**BOSTON PUBLIC HEALTH COMMISSION
Information and Technology Service
1010 Massachusetts Ave.
BOSTON, MA 02122**

ADDENDUM NO. 1

Specifications for: Fiber Installation Services

PROJECT NO.: Project No. IT-005-18

Mattapan

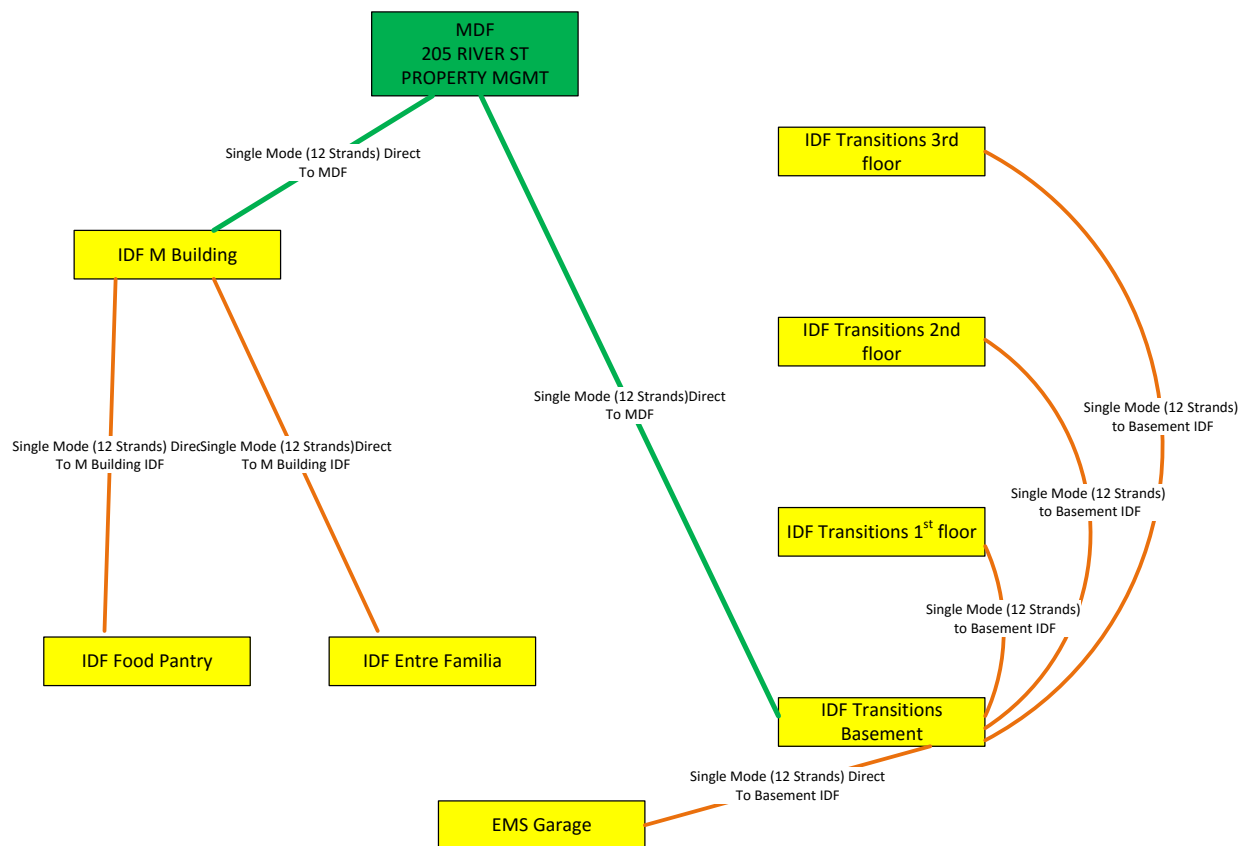
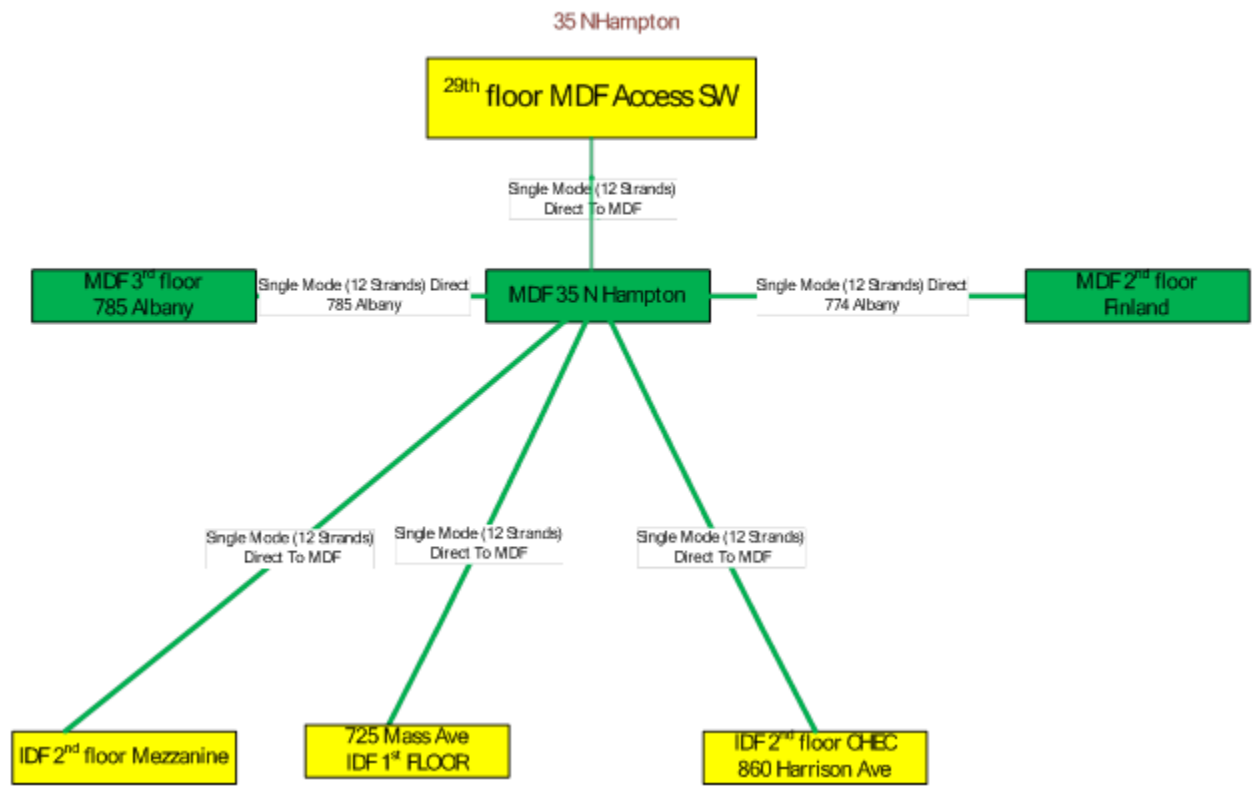
Q. 4 Mattapan Site: When we walked the site there was no pathway from MDF 205 River Street to the M Building thru the Foley Building. We have to assume that the pathway goes thru the abandon tunnel. We would need access into the tunnel from the Foley Bldg. We were not able to gain access into the Foley Bldg.

A. 4 Access will be granted as BPHC will exercise its easement rights to the tunnels. Access will be appropriately coordinated. The tunnels connect 205 River street, Foley Bldg. (249 River St) and the Food Pantry (213 River St)
